Progress Energy

Serial: HNP-09-095
10 CFR 50.55a

SHEARON HARRIS NUCLEAR POWER PLANT, UNIT NO. 1
DOCKET NO. 50-400/RENEWED LICENSE NO. NPF-63
RESPONSE TO REQUEST FOR ADDITIONAL INFORMATION REGARDING RELIEF
REQUESTS 2R1-018, 2R1-019, 2R1-020, 2R1-021, 2R1-022, 2R2-009, 2R2-010, AND
2R2-011 FOR THE SECOND 10-YEAR INSERVICE INSPECTION PROGRAM (TAC NOS.
ME0608, ME0609, ME0610, ME0166, ME0612, ME0613, ME0614, AND ME0615)

SHEARON HARRIS NUCLEAR POWER PLANT, UNIT NO. 1
DOCKET NO. 50-400/RENEWED LICENSE NO. NPF-63
RESPONSE TO REQUEST FOR ADDITIONAL INFORMATION REGARDING RELIEF
REQUESTS 2R1-018, 2R1-019, 2R1-020, 2R1-021, 2R1-022, 2R2-009, 2R2-010, AND
2R2-011 FOR THE SECOND 10-YEAR INSERVICE INSPECTION PROGRAM

COMPONENT ID: **RVNOZAI-N-01SE** ASME CATEGORY: B-F
 ASME CODE IWB-2500-8 ASME ITEM NUMBER: B5.130
 FIGURE:
 CONFIGURATION: ELBOW TO REACTOR VESSEL NOZZLE % CRV ACHIEVED: 85.15 %
 PROCEDURES: PDI-ISI-254-SE MATERIAL SS/CS
 WDI-STD-146
 WDI-STD-088

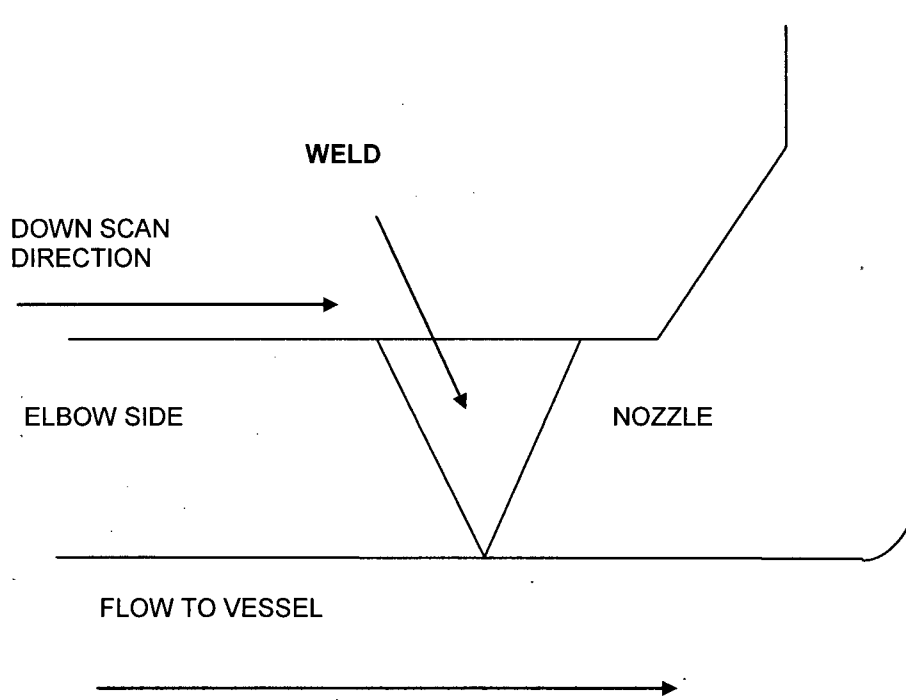
3c	Please explain how the "Combined UT [Ultrasonic] Coverage Total Percentage" in Sections 6.1, 6.2, and 6.3 of 2R1-018 is obtained.	An averaging method is used.
3d	Please provide information regarding when the ultrasonic testing inspection for each weld was performed (e.g., what ASME Code criteria were required - Appendix VIII or Section V)?	(Reference Relief Request submittal HNP-08-045 Sections 6.1, 6.2 and 6.3). UT examinations were performed with examination personnel and examination procedures qualified to ASME Code, Appendix VIII, as administered by the EPRI Performance Demonstration Initiative (PDI).
3e	Please provide more detailed information on the eddy current inspection methods performed, the inner diameter surface conditions of the affected welds, and an assessment of the ability to perform the eddy current testing exam effectively on these types of surface conditions.	Eddy Current procedure provided separately: WDI-STD-146

The coverage achieved was the maximum extent practical with the elbow to nozzle weld ID counter-bore and root configuration obstructions in place and the results are representative of the entire weld.

UT COMBINED COVERAGE = 85.15 %

ASME CODE IWB-2500-8 ASME ITEM NUMBER: B1.11
 FIGURE:

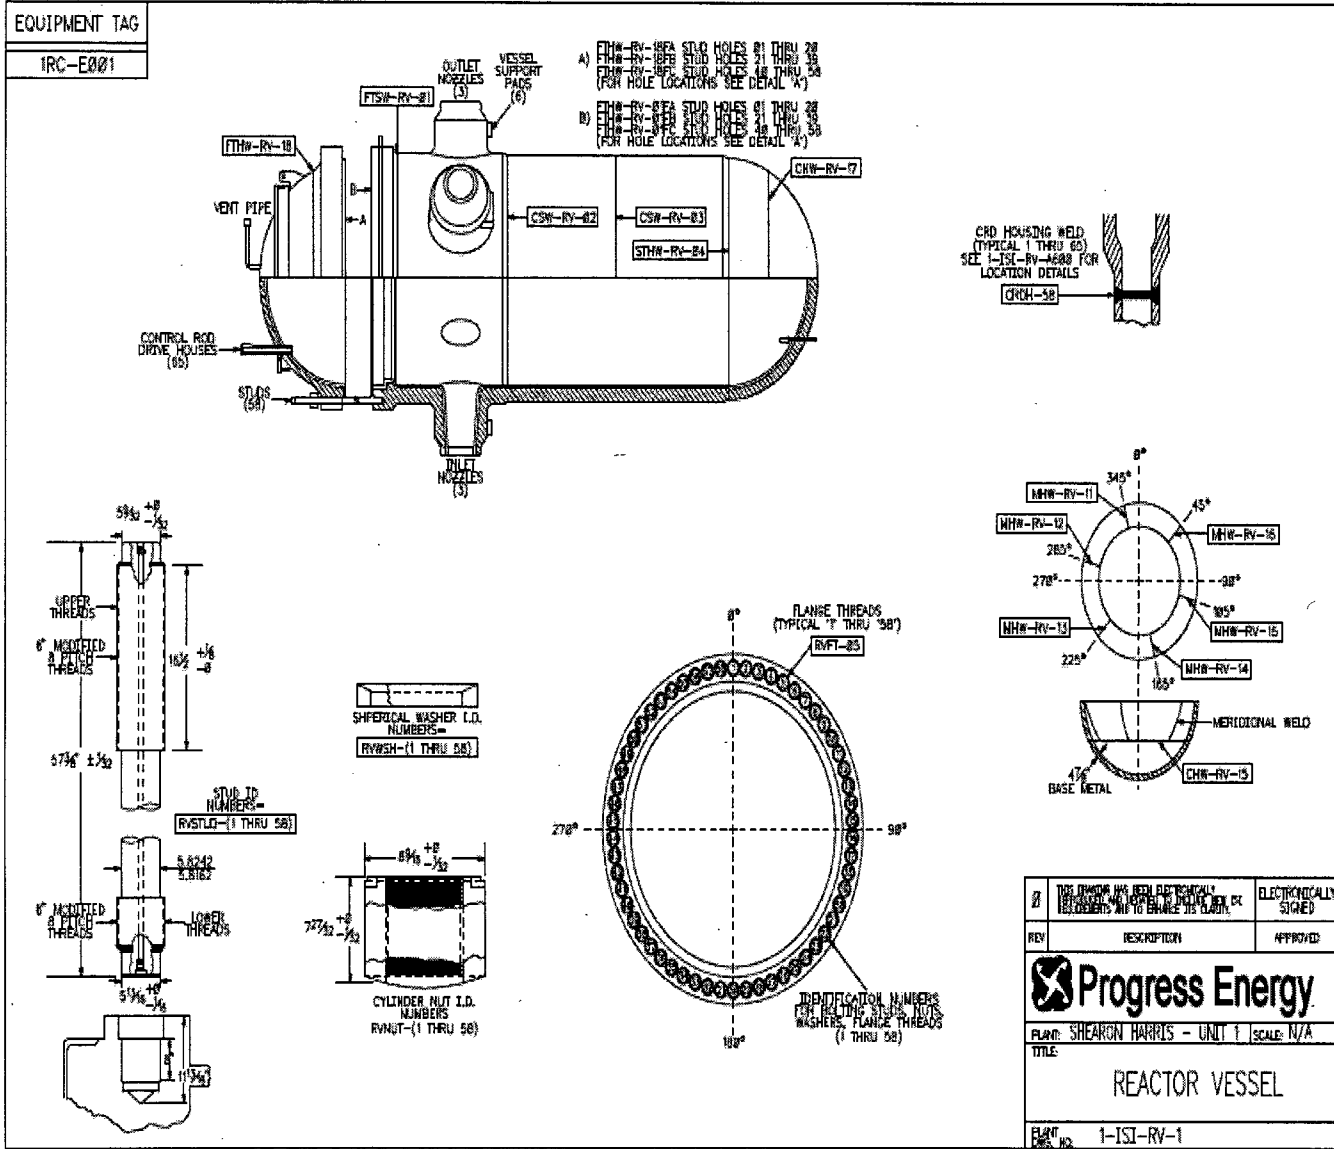
RAI	REQUEST	RESPONSE
1a	Description	(Reference Relief Request submittal HNP-08-045 Section 1.0). Welds are Lower shell to lower circumferential shell weld and lower head circumferential weld.
1a	Sketch	Information follows in Enclosure.
1a	Interference/Obstruction	(Reference Relief Request submittal HNP-08-045 Section 5.0). The limitation for Reactor Vessel Lower Head to Lower Shell Circumferential Weld STHW-RV-04 was due to the four core support lugs integrally attached to the reactor vessel. The limitation for Reactor Vessel Lower Head Circumferential Weld CHW-RV-17 was due to peripherally located Bottom Mounted Instrumentation (BMI) tubes integrally attached to the reactor vessel.
1b	NDE Equipment	The following procedure is provided separately: PDI-ISI-254
1b	Alternative Methods	(Reference Relief Request submittal HNP-08-045 Section 6.0). HNP is proposing to volumetrically UT examine the RPV pressure retaining welds STHW-RV-04 and CHW-RV-17 to the maximum extent possible in accordance with the Inservice Inspection Program schedule. A significant portion of the subject welds have been examined, obtaining 83.9% for weld STHW-RV-04 and 81.77% for weld CHW-RV-17. In addition, the subject welds are subject to visual (VT-2) system Leakage test during each refueling outage.

The coverage achieved was the maximum extent practical with the four core support lug obstructions in place and the results are representative of the entire weld.

UT COMBINED COVERAGE = 83.90 %

ASME CODE IWB-2500-4 ASME ITEM NUMBER: B1.30
 FIGURE:

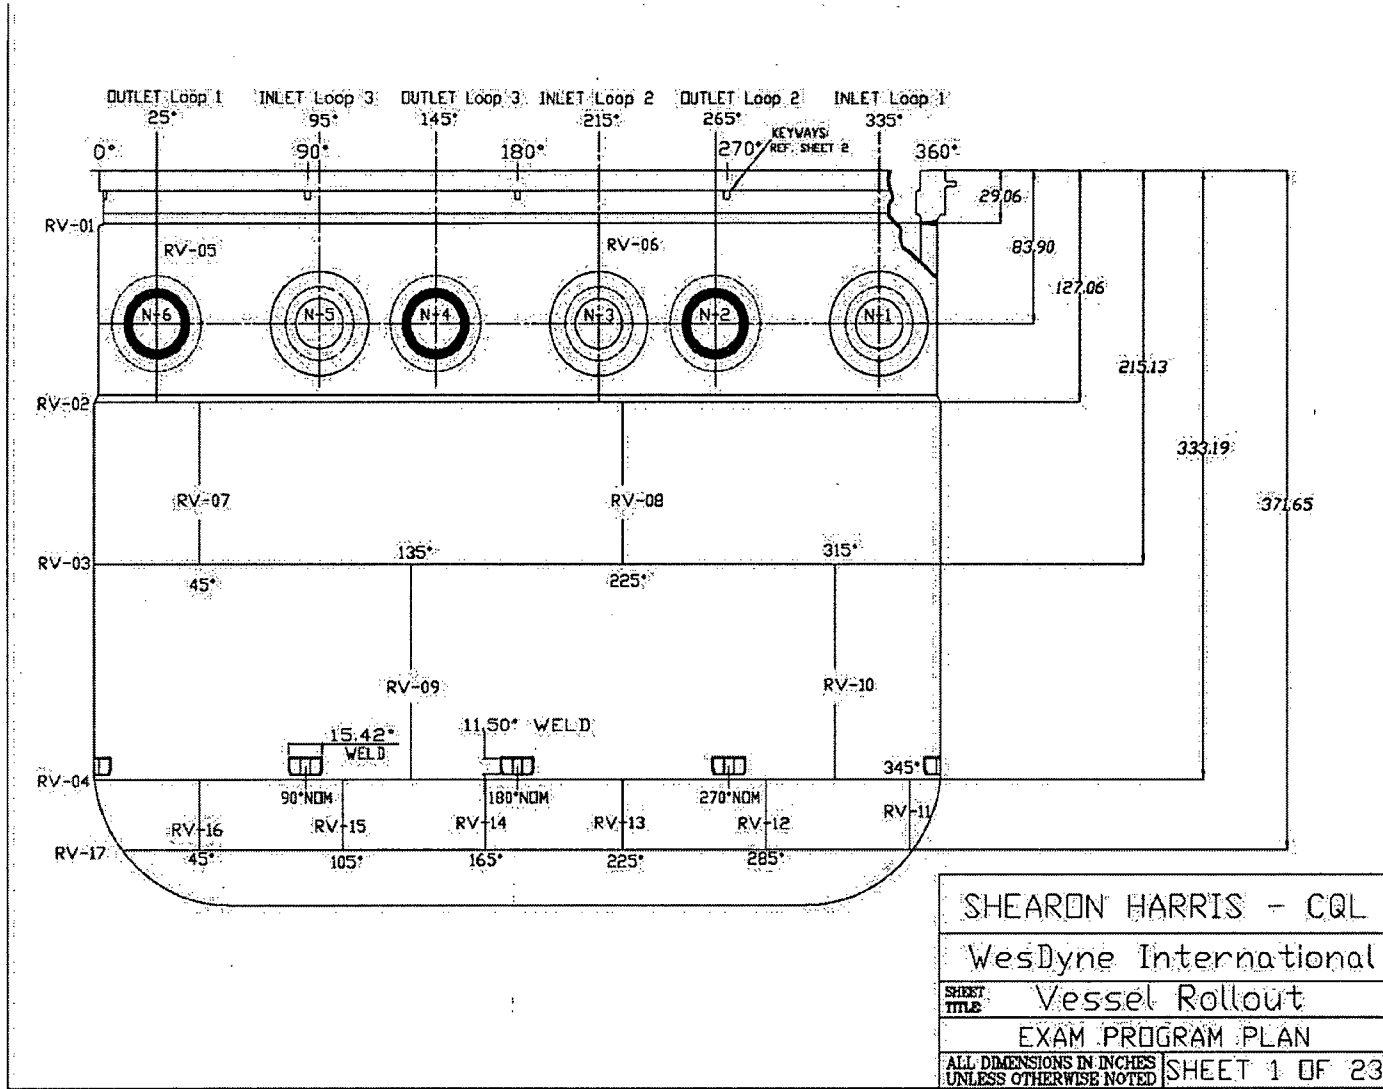
RAI	REQUEST	RESPONSE
1a	Description	(Reference Relief Request submittal HNP-08-045 Section 1.0). Welds are Vessel Flange to Upper shell weld and Vessel Flange to Head weld.
1a	Sketch	Information follows in Enclosure.
1a	Interference/Obstruction	(Reference Relief Request submittal HNP-08-045 Section 5.0). The limitation that reduces the amount of UT examination coverage for Vessel Flange to Upper Shell Weld FTSW-RV-01 is the vessel configuration at the flange. The limitations for the Vessel Flange to Head Weld FTHW-RV-18 is due to the component configuration (flange directly adjacent to the weld) and the vessel head lifting lugs.
1b	NDE Equipment	The following procedures are provided separately: PDI-ISI-254 (FTSW-RV-01) WDI-STD-146, WDI-STD-088 (FTHW-RV-18)
1b	Alternative Methods	(Reference Relief Request submittal HNP-08-045 Section 6.0). HNP is proposing to volumetrically UT examine the RPV pressure retaining welds FTSW-RV-01 and FTHW-RV-18 to the maximum extent possible in accordance with the Inservice Inspection Program schedule. In addition, the subject welds are subject to visual (VT-2) system Leakage test during each refueling outage. For FTHW-RV-18 Vessel Flange to Head Weld, the Code required MT Examination was also performed in accordance with the ASME Code Section XI.

The coverage achieved was the maximum extent practical due to the vessel configuration at the flange and the results are representative of the entire weld.

UT COMBINED COVERAGE = 87.5 %

COMPONENT ID: **NTHW-08** ASME CATEGORY: B-D
 ASME CODE IWB-2500-8 ASME ITEM NUMBER: B3.110
 FIGURE:
 CONFIGURATION: PRESSURIZER NOZZLE-TO-VESEL WELD % CRV ACHIEVED: 66 %
 PROCEDURES: ISI-210-T MATERIAL CS/CS
 PDI TECHNIQUE USED: YES

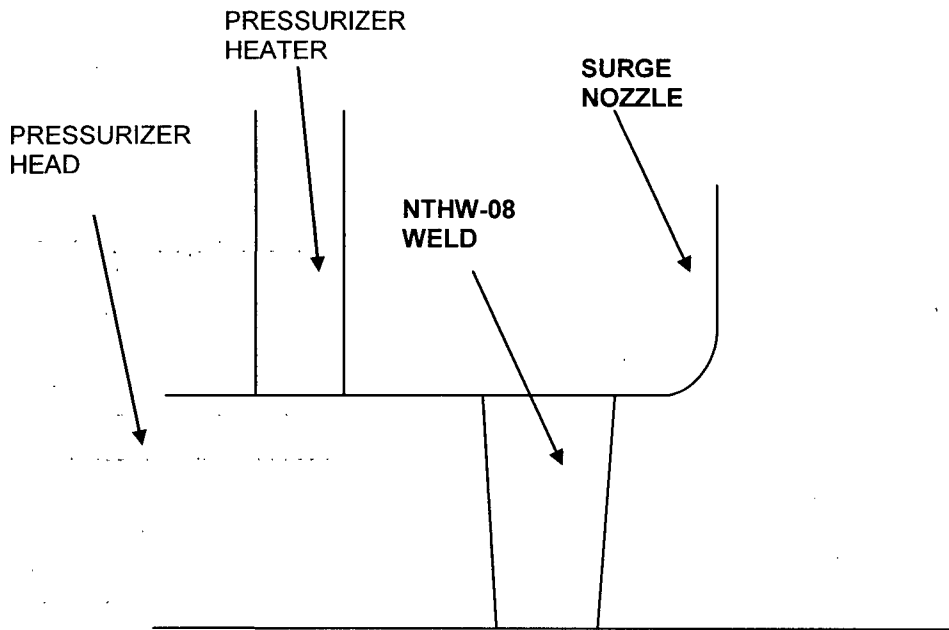
RAI	REQUEST	RESPONSE
1a	Description	(Reference Relief Request submittal HNP-08-045 Section 1.0). Welds are Pressurizer Nozzle to Head Welds.
1a	Sketch	Information follows in Enclosure.
1a	Interference/Obstruction	(Reference Relief Request submittal HNP-08-045 Section 5.0). Nozzle to vessel welds are not conducive to two-sided volumetric examinations due to nozzle configurations.
1b	NDE Equipment	Information follows in Enclosure.
1b	Alternative Methods	(Reference Relief Request submittal HNP-08-045 Section 6.0). HNP is proposing to volumetrically UT examine the pressurizer nozzle welds NTHW-08/-09/-10/-11/-12/-13 to the maximum extent possible in accordance with the Inservice Inspection Program schedule. In addition, the welds are subject to visual (VT-2) tests during each refueling outage.
1c	Wave Modality/ Insonification Angles	Information follows in Enclosure (“0° Longitudinal Wave Scan”, “45° and 60° Shear Wave ½ Vee Scan”).

The coverage achieved was the maximum extent practical with the nozzle to shell configuration and the pressurizer heater obstructions in place and the results are representative of the entire weld.

UT COMBINED COVERAGE = 66 %
